COUNCIL SUPPLEMENTARY ASSESSMENT REPORT

SYDNEY SOUTH PLANNING PANEL

PANEL REFERENCE & DA NUMBER	PPSSSH-182 – DA-1182/2024
PROPOSAL	Redevelopment of the Compass Centre site including the demolition of all existing structures, tree removal, site preparation and early works, bulk excavation, remediation works, and construction of a mixed-use development comprising a 2-level basement and a 5-storey mixed-use podium with 3 towers above, including a 19-storey hotel tower and 2 x 24-storey residential towers.
ADDRESS	Lot 19 and 20, DP 5541 Lot 18B, DP 412699 Lot 15, 16, 17, 21, 22, 23, 24, and 27, DP 5541 Lot 1, DP 507818 Lot 1, DP 207810 83, 85 and 99 North Terrace, Bankstown
APPLICANT	Altis Bulky Retail Pty Limited
OWNER	The Trust Company (Australia) Limited
DA LODGEMENT DATE	22 October 2024
APPLICATION TYPE	Integrated Development Application
REGIONALLY SIGNIFICANT CRITERIA	Section 2.19(1) and Clause 6 of Schedule 6 of <i>State Environmental Planning Policy (Planning Systems) 2021</i> declares the proposal regionally significant development as the proposal is for development that has an estimated development cost of more than \$30 million.

Figure 2: Landscape Masterplan (Source: Site Image)

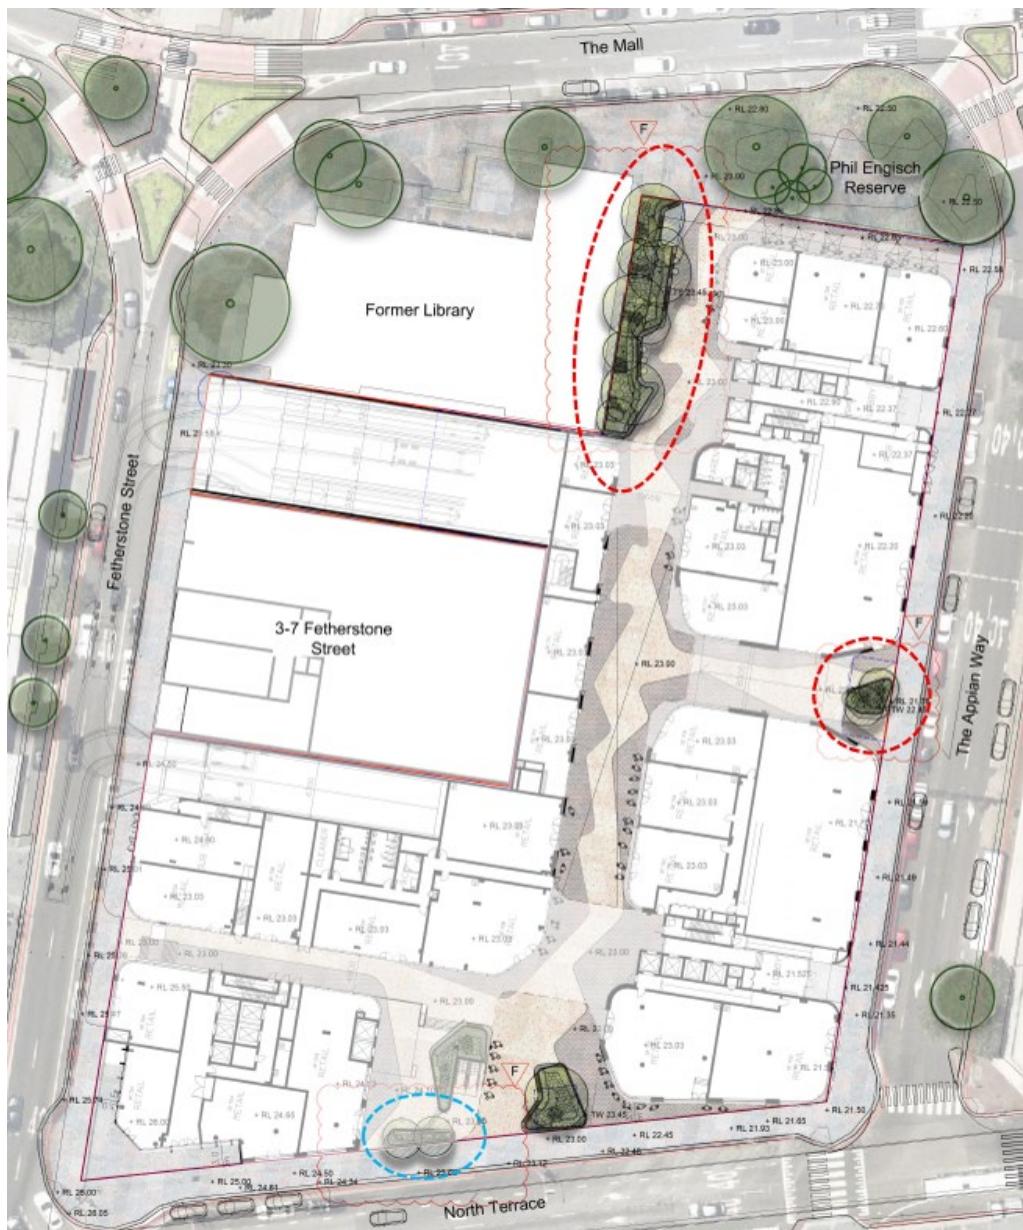
As identified in the original assessment report, increased deep soil areas could be achieved with enlarged or additional deep soil plantings/nodes along edges of the site, particularly along The Appian Way and/or Fetherstone Street frontage to maximise plantings, specifically canopy trees.

In response, the Applicant has provided amended landscape plans, prepared by Site Image, demonstrating the following improvements to the proposed landscaping at the ground level:

- Increased planting density and canopy zone within the existing northern and eastern deep soil zones. An additional three (3) Water Gum trees (*Tristaniopsis laurina*) have been included in the northern deep soil zone and three (3) cabbage tree palm trees (*Livistona australis*), have been replaced with two (2) Water Gum trees within the eastern deep soil zone (marked in red in Figure 2 below); and
- Additional planter along the southern North Terrace frontage (marked in blue in Figure 2) with additional tree and shrub plantings including two (2) Water Gum trees.

Additional tree plantings are also proposed on upper levels which has increased the total canopy coverage on site from 39.9% to 42.7%.

Accordingly, it is considered that the development as amended is consistent with Objective 3E-1 of the ADG and is acceptable on this basis.

Figure 3: Original (top) and proposed amended (bottom) solar access diagram (Source: PTW Architects)

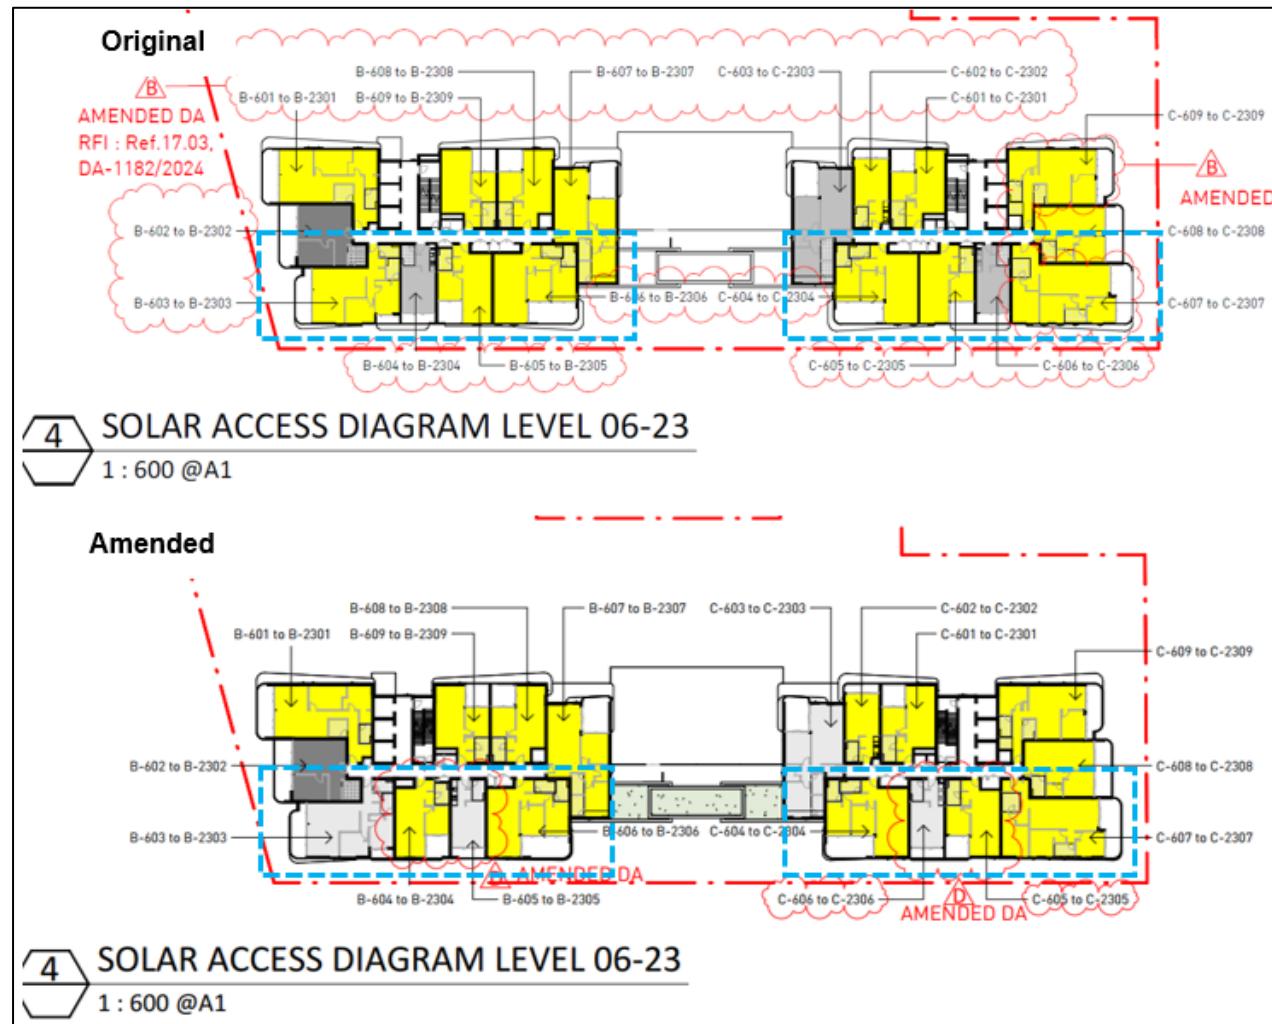
The original proposal and the amended apartment configuration and reduced slab projections of the east facing apartments are illustrated in Figure 3 (marked in blue).

Based on the additional material provided, it is considered that Units B604, B605, B606, C604 and C605 will receive a minimum of 2 hours of sunlight (between 9am and 11am) as required under Design Criteria 1 in Objective 4A-1 of the ADG.

Figure 6: Solar penetration diagram; Building B at 9am 21st June (Source: PTW Architects)

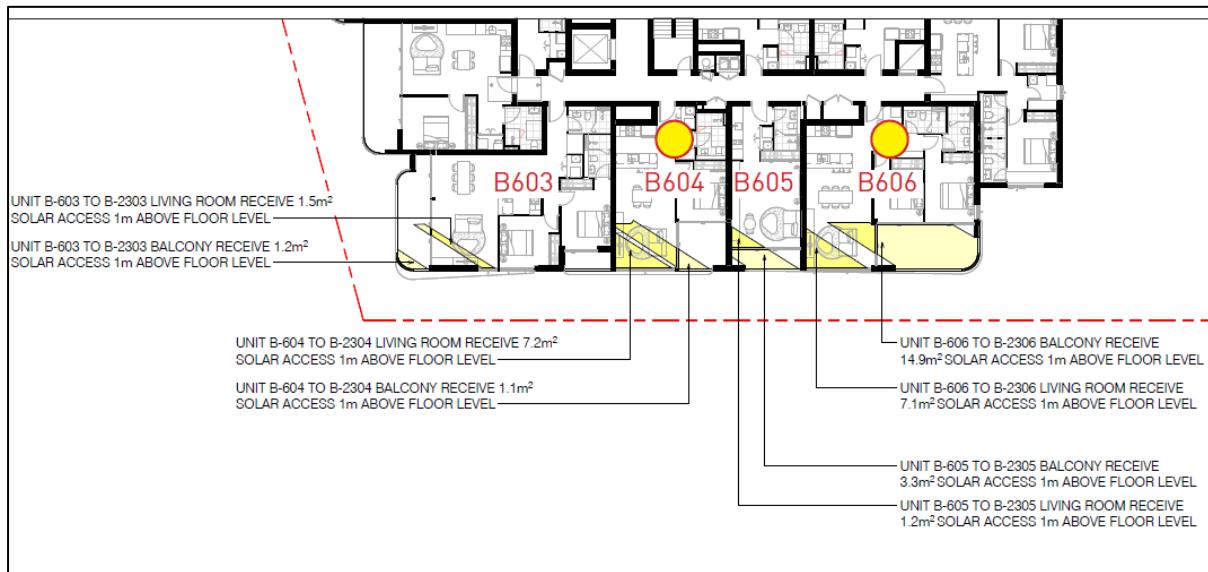
The additional solar penetration diagrams are shown in Figures 6 to 9.

Figure 10: Original (top) and proposed amended (bottom) typical Units B-08/09, Building B (Source: PTW Architects)

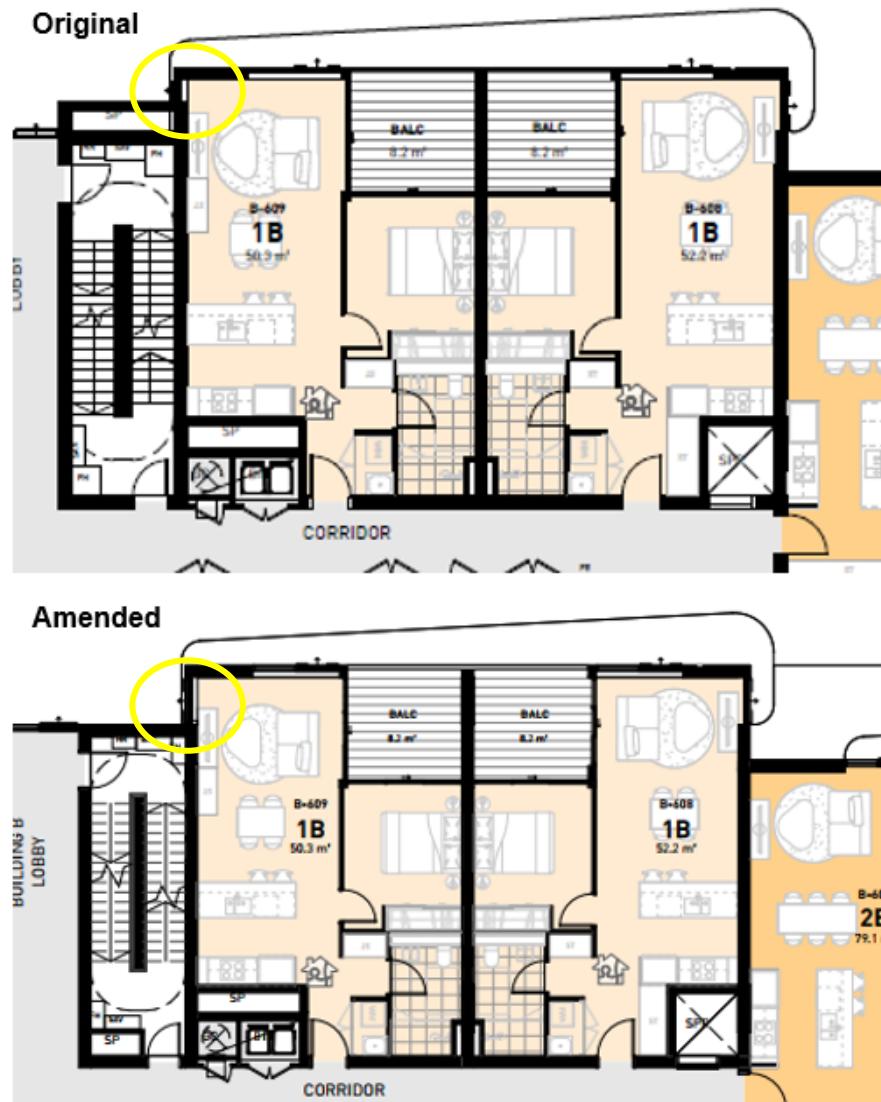
The original proposal and the amended windows are illustrated in Figure 10.

In response, the Applicant has provided amended plans which demonstrate increased outlet windows for Units B609, B709, B809, B909, C601, 701, 801 and C901. This has been achieved by removing and relocating the stair pressurisation enclosure and thereby increasing the size of the window on this elevation.

Figure 11: Original (top) and proposed amended (bottom) typical Unit C-01, Building C (Source: PTW Architects)

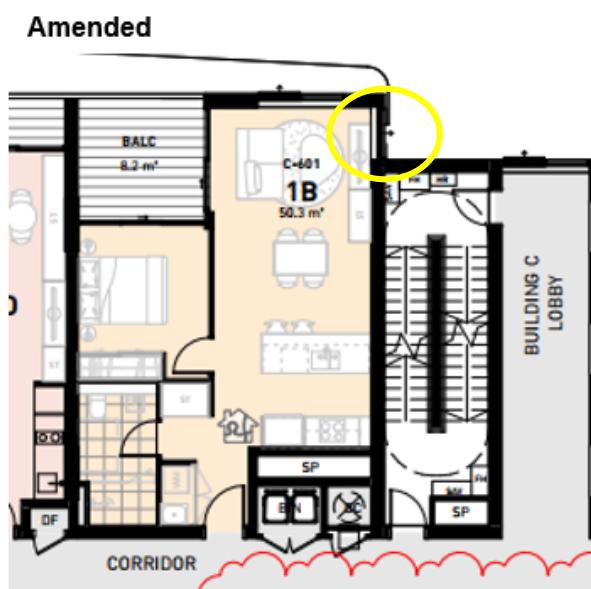
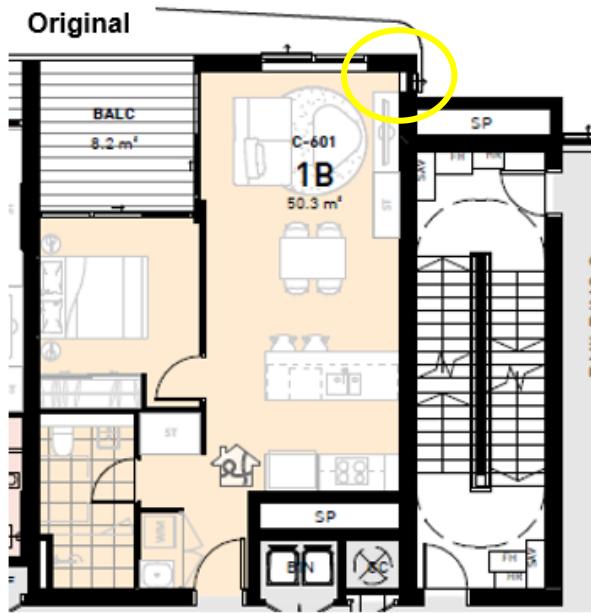
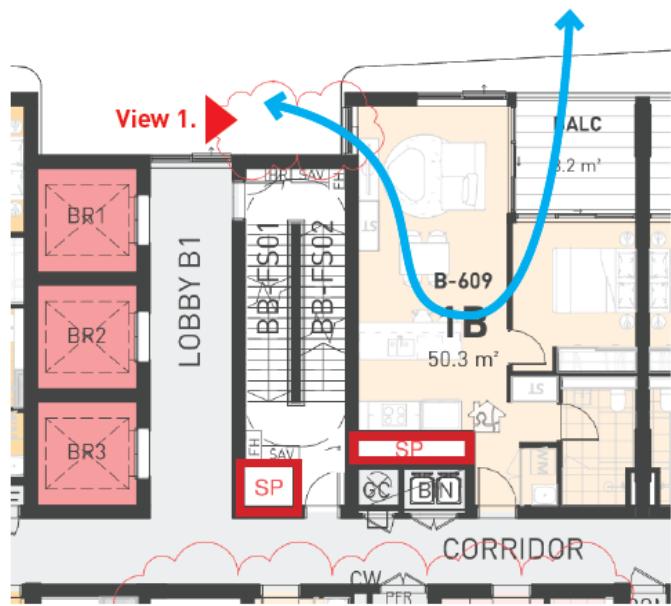
Additional details, including elevations, have also been provided confirming that the outlet openings for Units B608 B609, B708, B709, B808, B809, B908 and B909 in Building B, as well as unit C601, 701, 801 and C901 are awning windows, with floor to ceiling glazing (refer to Figure 11 and 12).
